Technical Service Information Bulletin

Title: HVAC EVAPORATOR DRAIN BLOCKAGE

Models: '06 GS 300, '06 – '07 GS 430 & IS 250/350, & '07 GS 350/450h

REVISSED
AC003-07
HEATING & AIR CONDITIONING

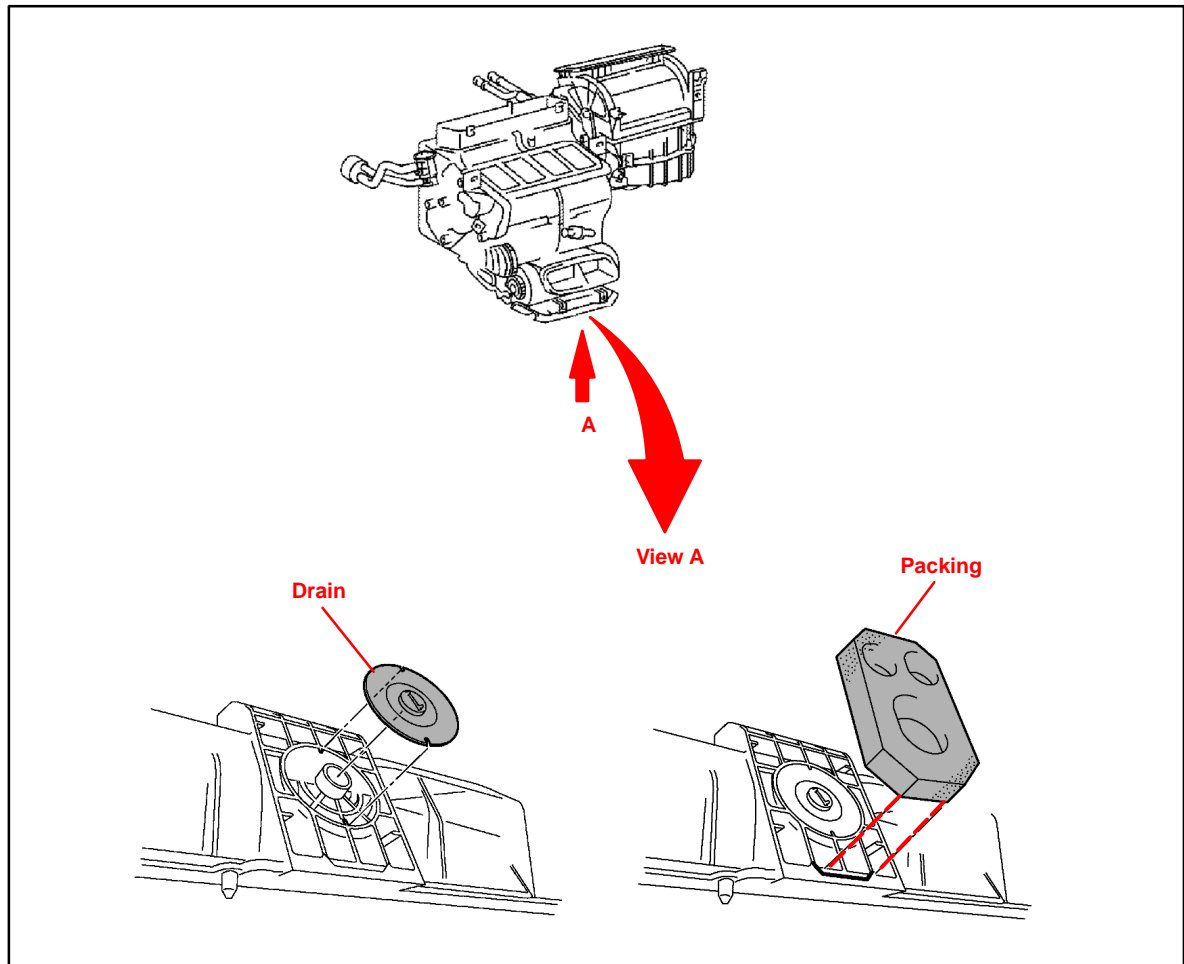
Introduction Some customers may experience water on the front or rear carpets of the vehicle due to the HVAC evaporator drain becoming blocked by debris. An improved HVAC evaporator drain and packing have been made available as separate serviceable parts. Use the following repair procedure to correct this concern.

PREVIOUS PART NUMBER	CURRENT PART NUMBER	PART NAME	QTY
N/A	88578-30870	Packing Cooler, No. 1	1
N/A	87128-30050	Grommet, Heater	1

1. Remove the air conditioning unit.
Refer to the Technical Information System (TIS), applicable model year and model Repair Manual, *Vehicle Interior – Heating/Air Conditioning – “Air Conditioning: Air Conditioning Unit: Removal”*.
2. Remove the HVAC evaporator drain and packing.

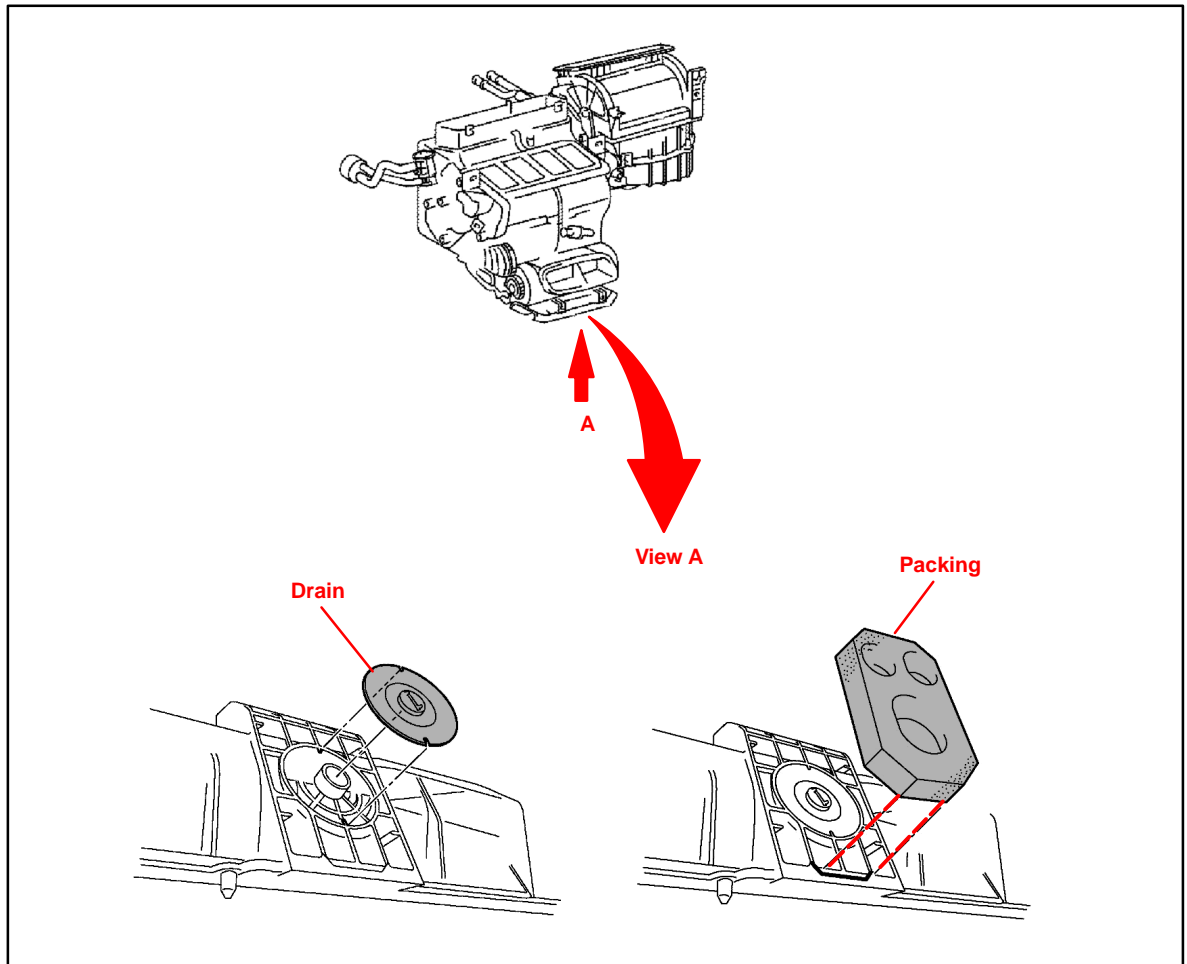
3. Install the NEW HVAC evaporator drain and packing to the air conditioning unit.
